# 1990 - 1992 Corvette ZR-1: Service Bulletin: No Start Condition (Replace Starter)

**Subject:** NO START CONDITION (STARTER CORROSION-REPLACE STARTER)

**Model and Year:** 1990-1992 Corvette, Engine Code J (LT5)

**Bulletin Number:** 92-307-6 - (09/21/1992)

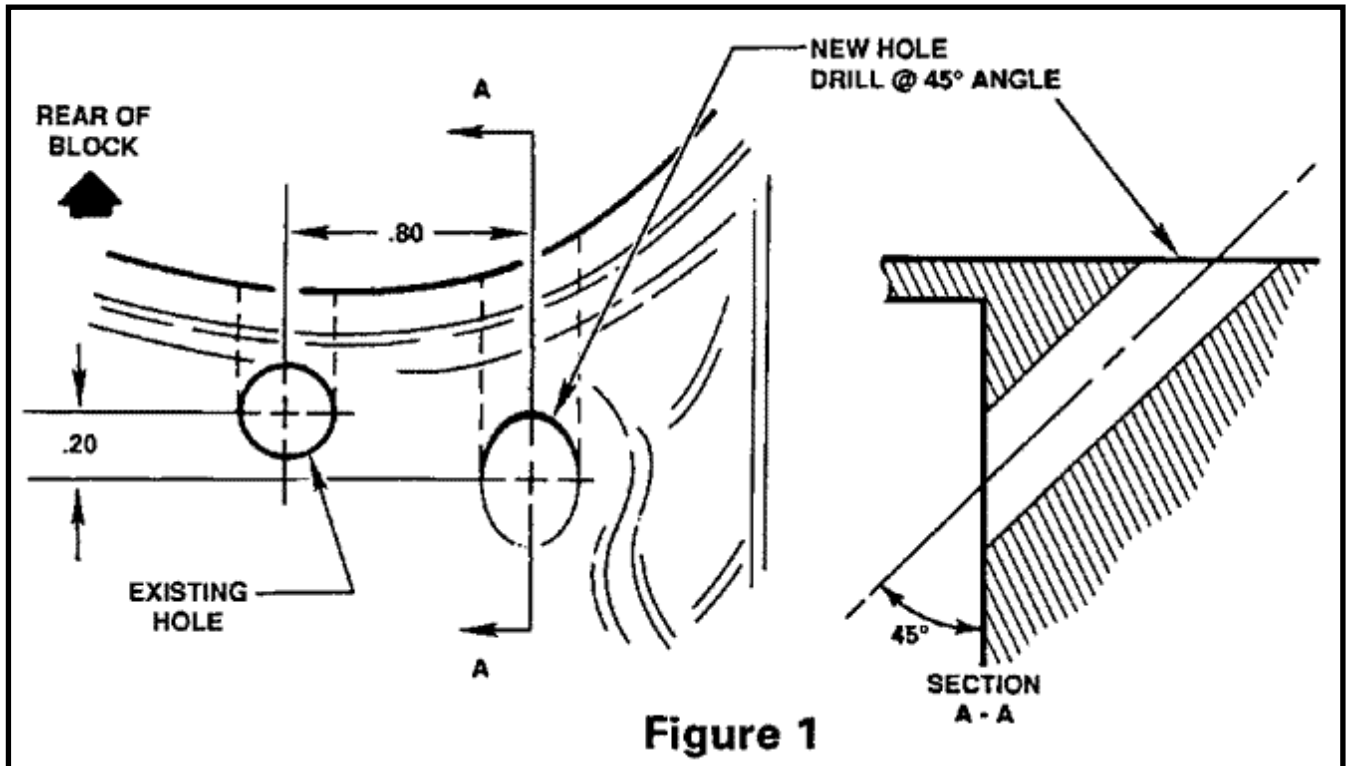
Some ZR1 Corvettes may exhibit a no start condition due to starter corrosion. This condition is most likely to occur after the engine has been washed.

The starter on an LT5 engine is mounted in the engine "vee." A drain hole and drain tube are located at the rear of the engine valley. While washing the engine, debris may settle in the engine "vee" and block the drain system.

- 1 . Remove the old starter.
2. Clean any blockage in existing drain system.
3. Drill a 3/8" diameter hole through the engine "vee" to the back of the engine, allowing drainage (see Figure 1).

4. Install new starter, p/n 10455704.
